SHEARON HARRIS NUCLEAR POWER PLANT, UNIT NO. 1
DOCKET NO. 50-400/LICENSE NO. NPF-63
CYCLE 16 CORE OPERATING LIMITS REPORT

SHEARON HARRIS NUCLEAR POWER PLANT
DOCKET NO. 50-400/LICENSE NO. NPF-63
CYCLE 16 CORE OPERATING LIMITS REPORT

SUMMARY OF CYCLE 16 COLR REVISIONS

Harris Unit 1 Cycle 16
Core Operating Limits Report - Rev. 0

Figure 5
Cycle 16 V(Z) Versus Core Height
0 MWD/MTU ≤ burnup < 15000 MWD/MTU

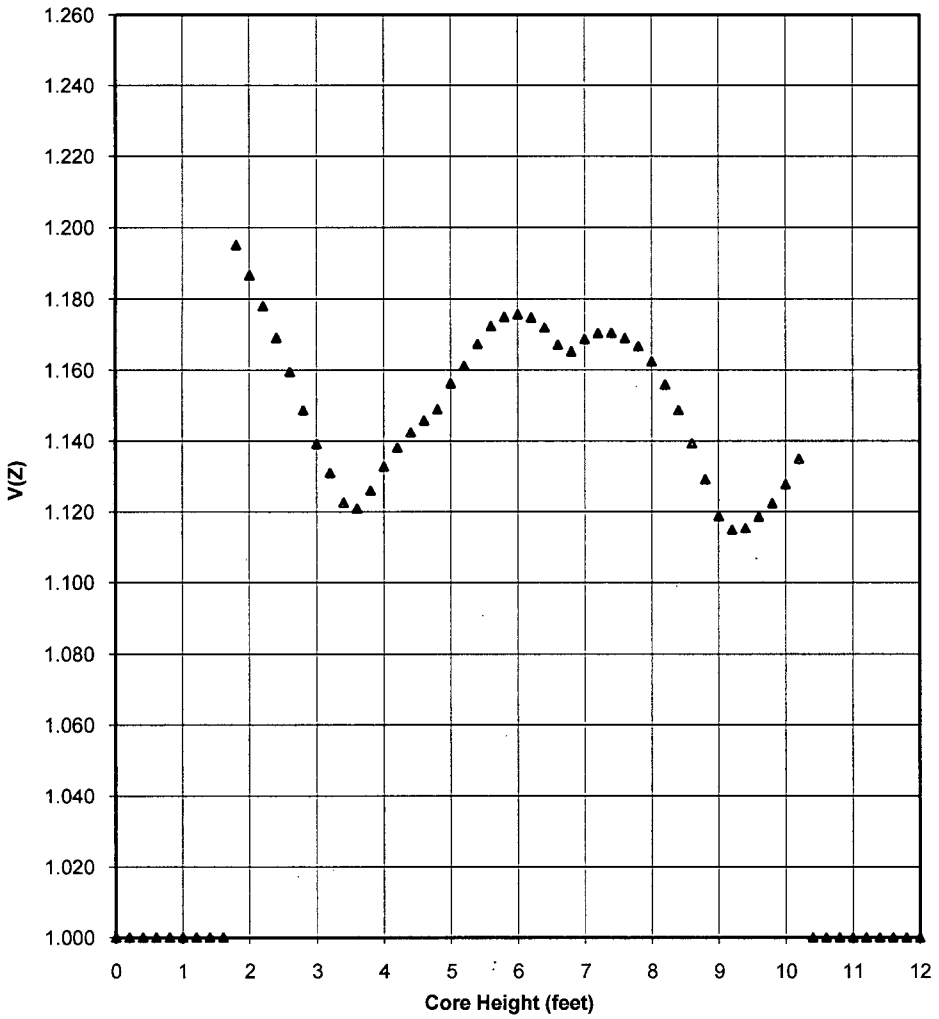
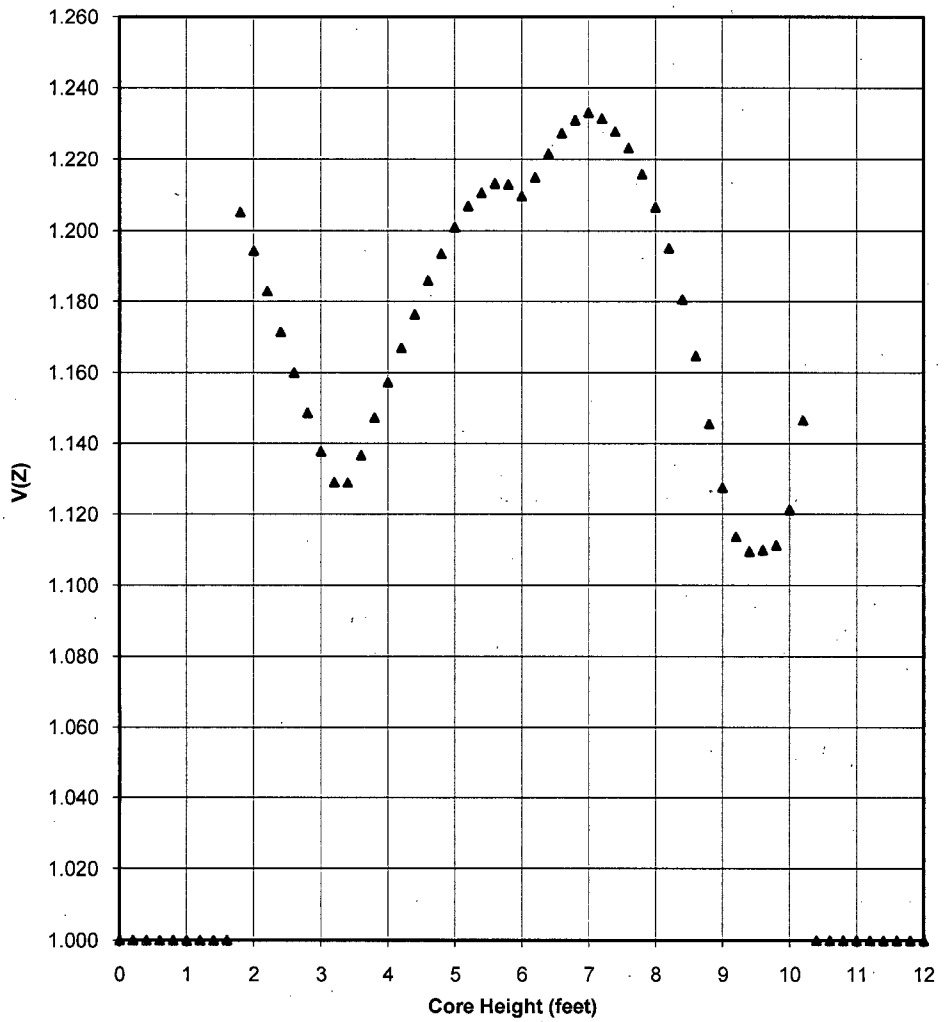
Section	Description of Change
All	Updated Attachment 9 Title to Cycle 16, rev. 0. Updated Sheet numbers. Changed all references of Cycle 15 to Cycle 16.
2.2.2	Changed -42.0 to -42.1.
2.6.2	Deleted third and fourth sentence. Changed "fourth v(z) curve" to "second v(z) curve". Changed 21463 to 20540. Changed 18000 to 15000. In first sentence, changed figure "8" to figure "6".
2.8	Changed 2172 to 2183.
3.0.9	Changed FANP to AREVA NP.
3.0.13	Added "(Not used in Cycle 16)"
3.0.14	Deleted Last referenced letter from R. A. Copeland.
Figures 5 & 6	Replaced figures 5 and 6 with new Cycle 16 updated figures.
Figures 7 & 8	Deleted figures 7 and 8.

2. V(Z) Curves versus core height for PDC-3 Operation, as used in T.S. 4.2.2, are specified in Figures 5 through 6. The first V(Z) curve (Figure 5) is valid for Cycle 16 burnups from 0 up to but not including 15000 MWD/MTU. The second V(Z) curve (Figure 6) is valid for Cycle 16 burnups greater than or equal to 15000 MWD/MTU to a maximum cycle energy of 20540 MWD/MTU.
